9210100 PORTLAND CEMENT AND BLENDED CEMENT
INTERNAL/INDUSTRY REVIEW COMMENTS

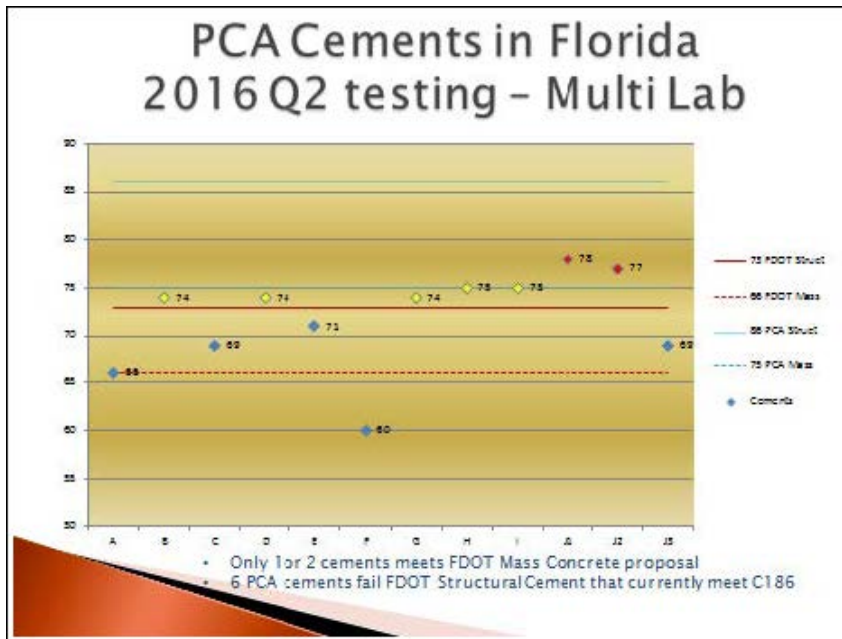
921-1.3 Heat of Hydration: The cement heat of hydration for Type II (MH) shall be ~~88°73~~ cal/g or less at ~~7°three~~ days when tested in accordance with ASTM ~~C186~~ **C1702**. For Type II (MH) used in mass concrete, the cement heat of hydration shall be ~~80°66~~ cal/g or less at ~~7°three~~ days when tested in accordance with ASTM ~~C186~~ **C1702**.

Industry Proposals: According to the FDOT no concrete failures due to temperature rise have been documented due to cements currently supplied to Florida projects. Concrete temperature rise is governed by the overall concrete mix design, and reporting of cement heat of hydration supports the calculation of the concrete temperature rise for the end user. Industry proposal is to require heat of hydration values be reported for cements to allow concrete temperature rise to be estimated, but to place no limits on those values in 921-1.3. We also recommend that the newer Type II cements be treated the same way for heat of hydration as the Type I/II MH in FDOT specs.

921-1.3 Heat of Hydration: The cement heat of hydration for Type II (MH) shall be ~~88~~ **reported** at ~~7~~ **three** days when tested in accordance with ASTM ~~C186~~ **C1702**. For Type II (MH) used in mass concrete, the cement heat of hydration shall be **reported** at ~~7~~ **three** days when tested in accordance with **ASTM C1702**.

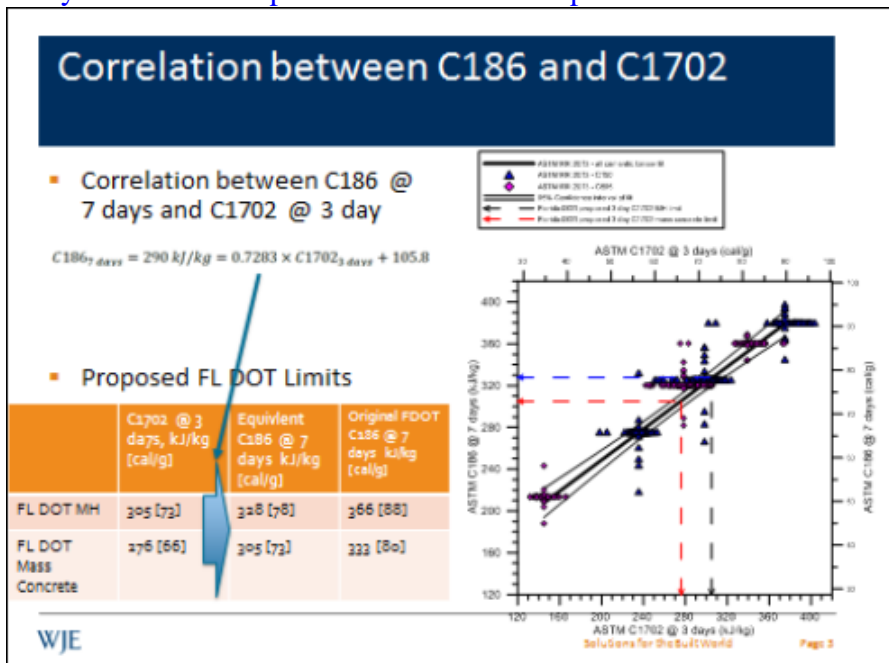
A primary concern with the initial FDOT 921-1.3 proposal is that 58% of cements supplied to Florida would not meet the proposed heat of hydration limit (73 cal/g) for cements used in structural concrete applications and 83% of cements would not meet the proposed limit for heat of hydration (66 cal/g) for cements used in mass concrete applications, as noted in the figure below:

The ASTM C01.26 subcommittee chairman has prepared a graph presenting data from round robin testing showing the relationship between 7-day C186 vs 3-day C1702 values. Regression analysis of that data provides the relationship between the two test methods in the table above.
